November 10, 2022

Subject: Beresford Elementary School HVAC Replacement
San Mateo - Foster City School District
Aedis Project No. 2021011.04
DSA Application #01-120124

ADDENDUM NO. 1

1 NEW SINGLE LINE DIAGRAM

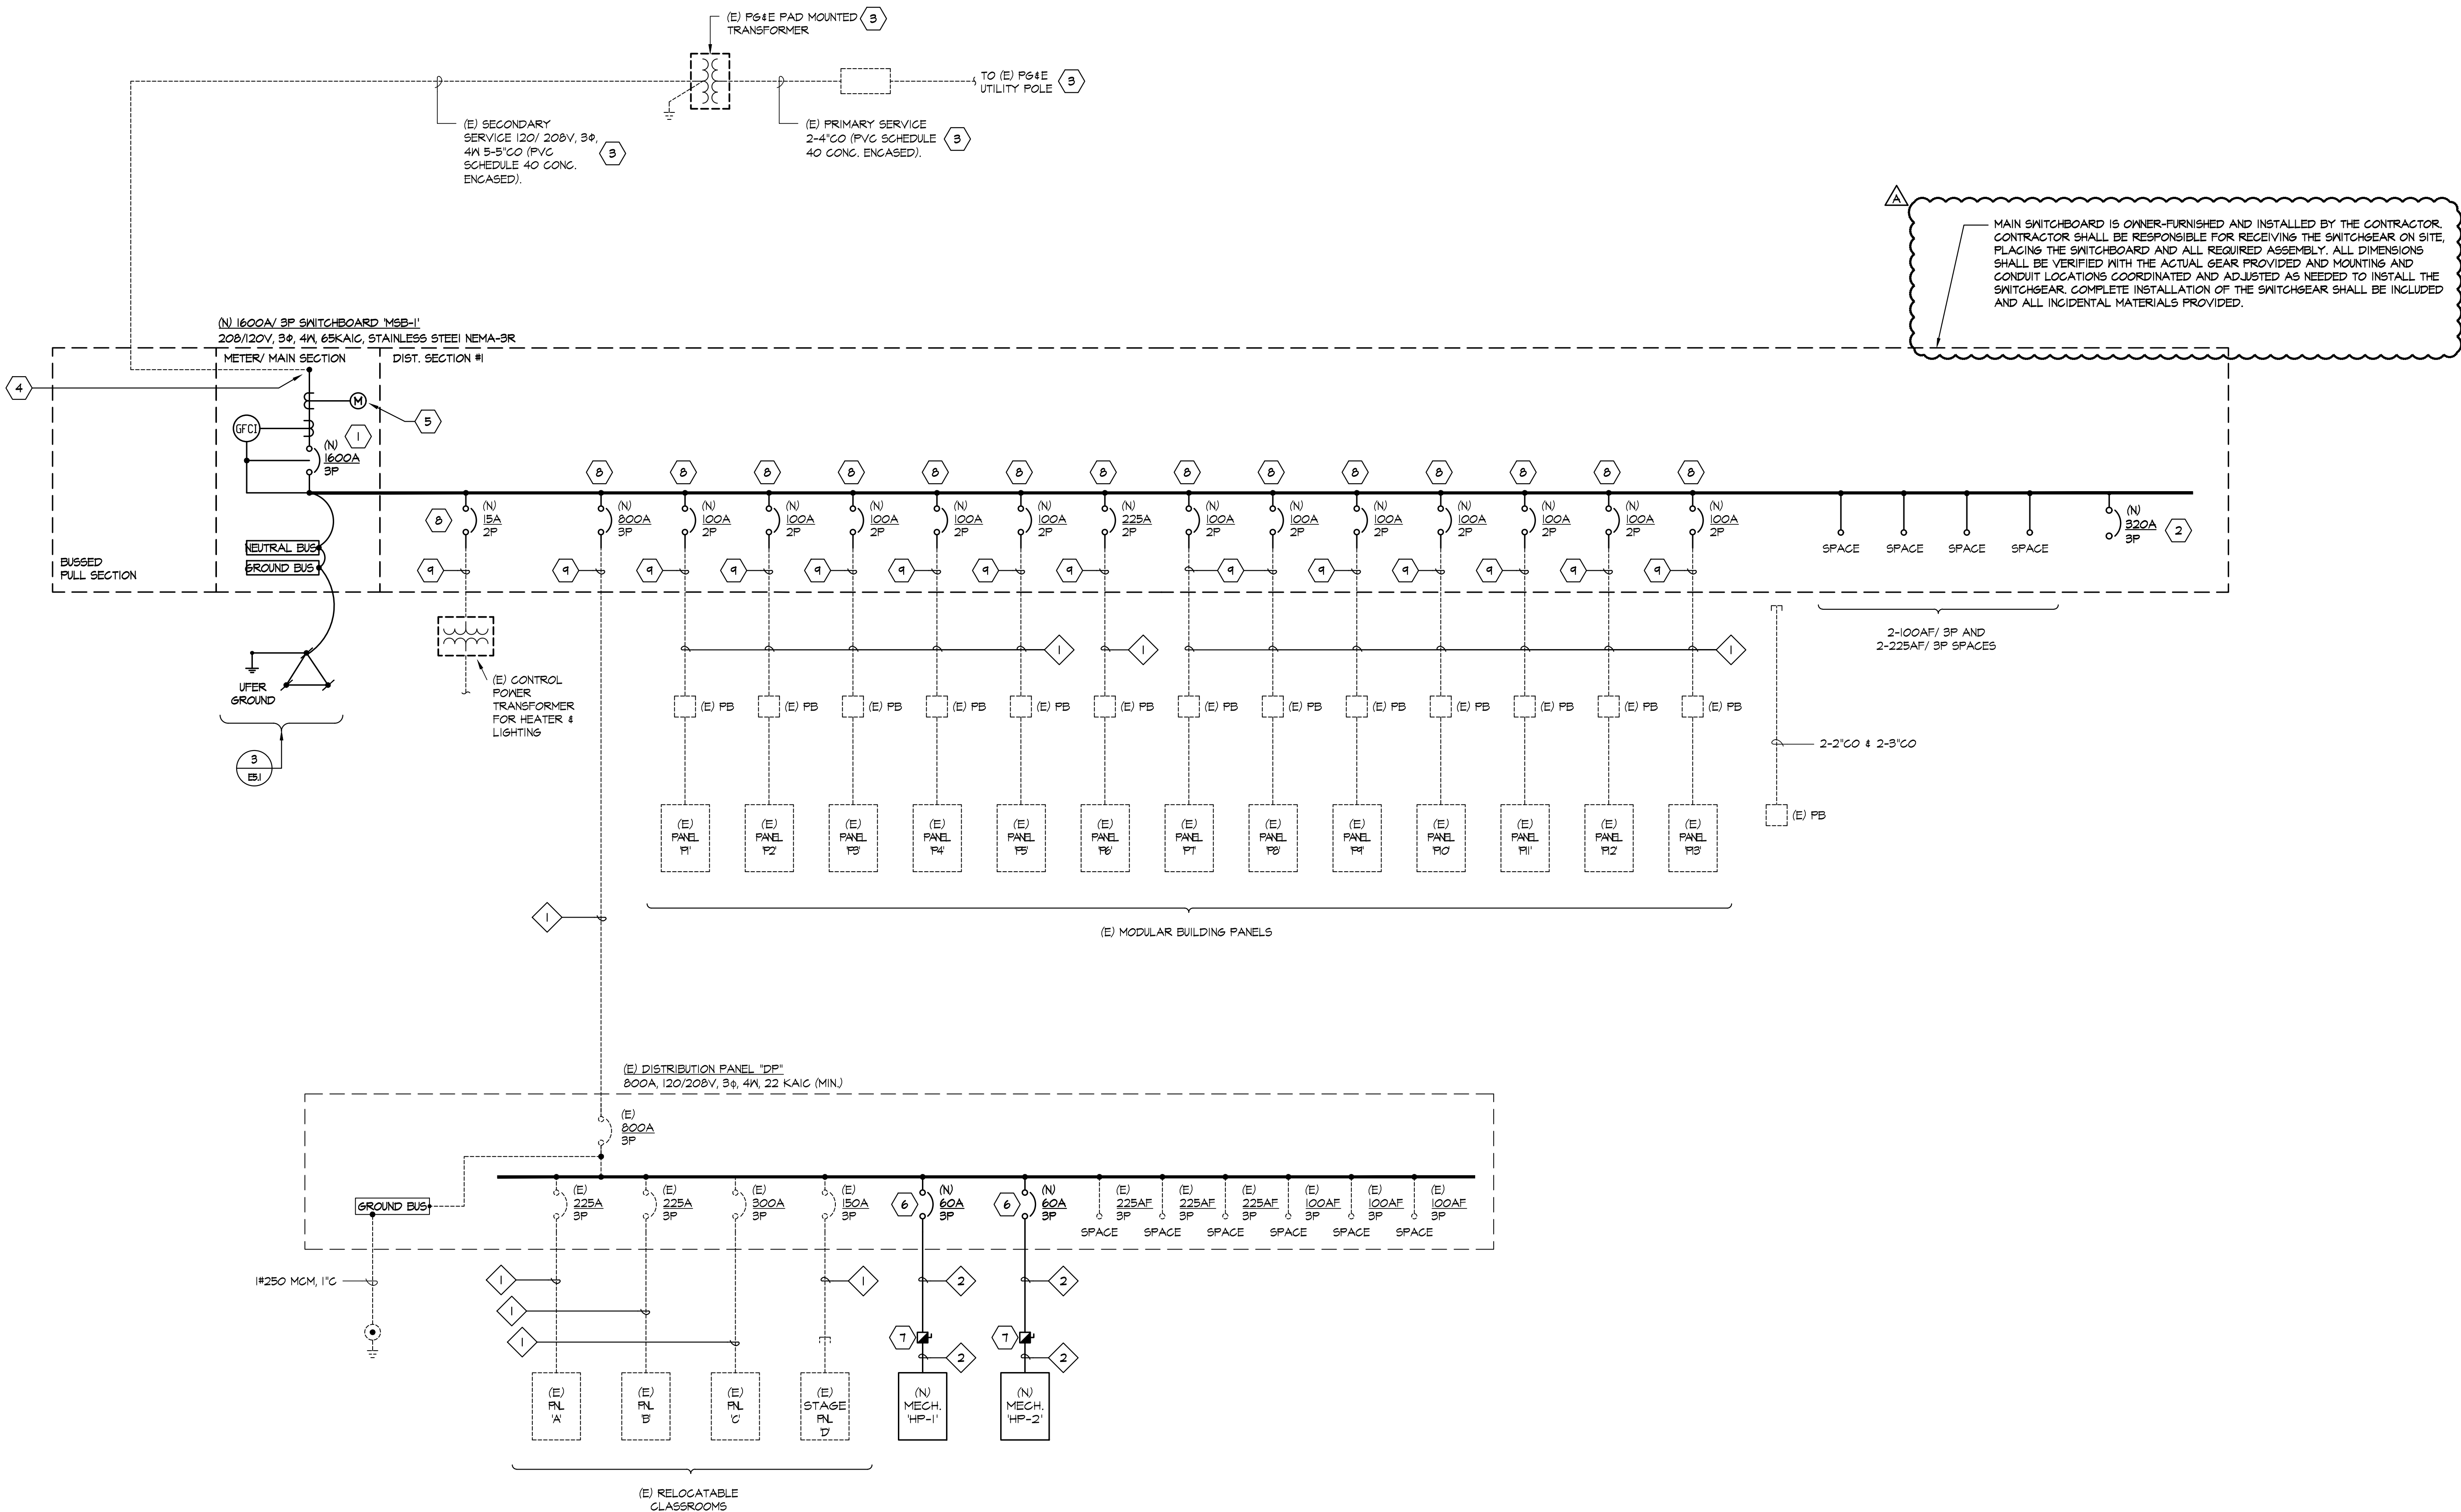
ITEM NO. 1.17: DRAWING SHEET E4.2 – NEW SINGLE LINE DIAGRAM

- Revise: General Note #11 as clouded per AD1-E4.2
- Add: General Note #12 as clouded per AD1-E4.2
- Add: OFCI note tag at New Single Line Diagram as clouded per AD1-E4.2

NEMA 3R MAIN SWITCHBOARD ELEVATION AND ANCHORAGE DETAIL

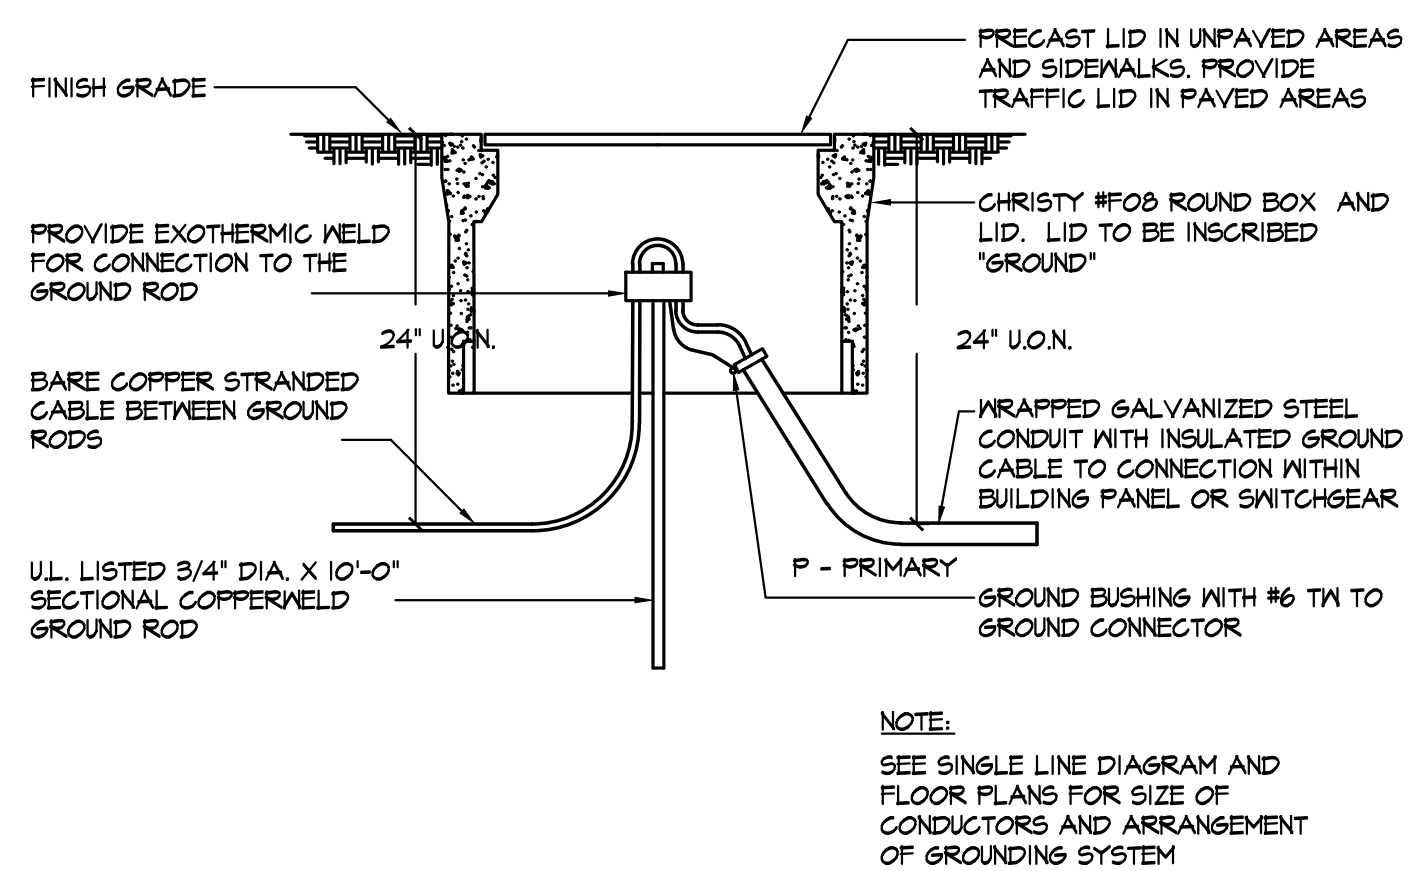
ITEM NO. 1.18: DRAWING SHEET E5.1 – ELECTRICAL DETAILS

- Revise: NEMA 3R Main Switchboard Elevation and Anchorage Detail as clouded per AD1-E5.1
